ITEM FOR ENVIRONMENTAL BOARD AGENDA

OVERLOOK AT DAVENPORT
SPC-2012-0425C

Variance request is as follows:
1. To allow fill greater than 4 feet not to exceed 11.8 feet
Lake Austin Watershed Ordinance Section 9-10-409(a)

SUBJECT: Overlook at Davenport – SPC-2012-0425C

**Fill Exhibit**

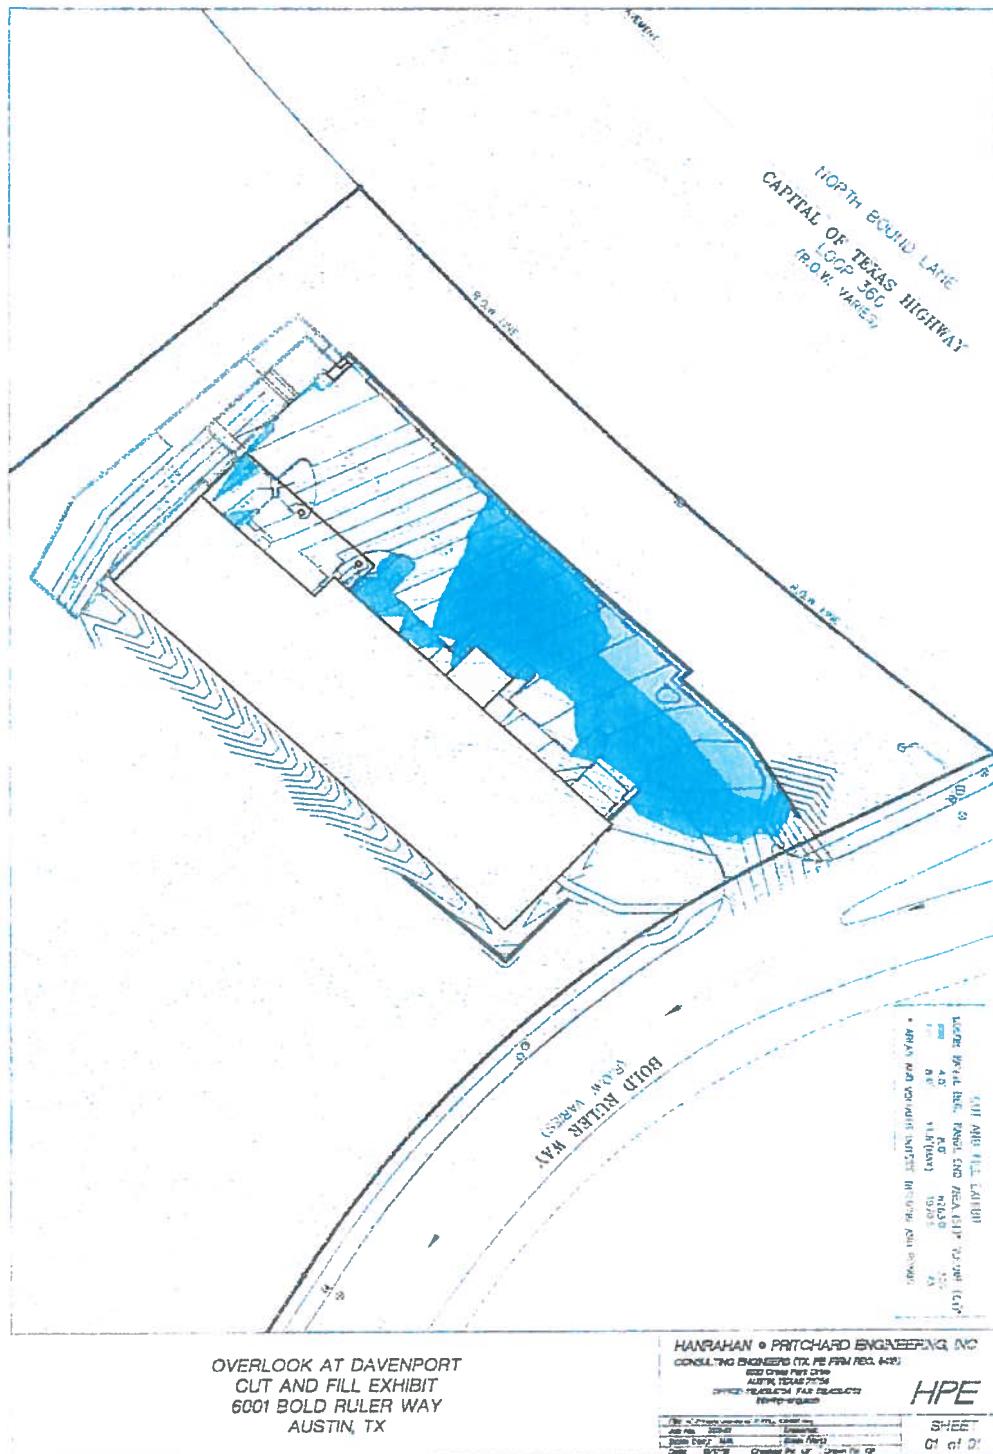
Extent of Fill. The area affected by this variance is primarily within the drive and loading area of the surface parking lot. A structural wall is proposed along the west side of the parking area, finished ground in this area reaches a maximum height of 11.8 feet. In addition, portions of pond walls exceed four feet as shown in the exhibit on sheet 15 accompanying this request.

In order to minimize disturbance of a larger area of the site, the pond has been designed with walls as shown on the attached exhibit on sheet 15. The design height of the pond walls require fills in excess of four feet in the parking lot immediately adjacent to the pond. No fill is proposed within the pond area.

The project proposes up to 11.8 feet of fill in areas shown on the attached fill exhibit. The Lake Austin Ordinance allows a maximum of four feet of fill without a variance.
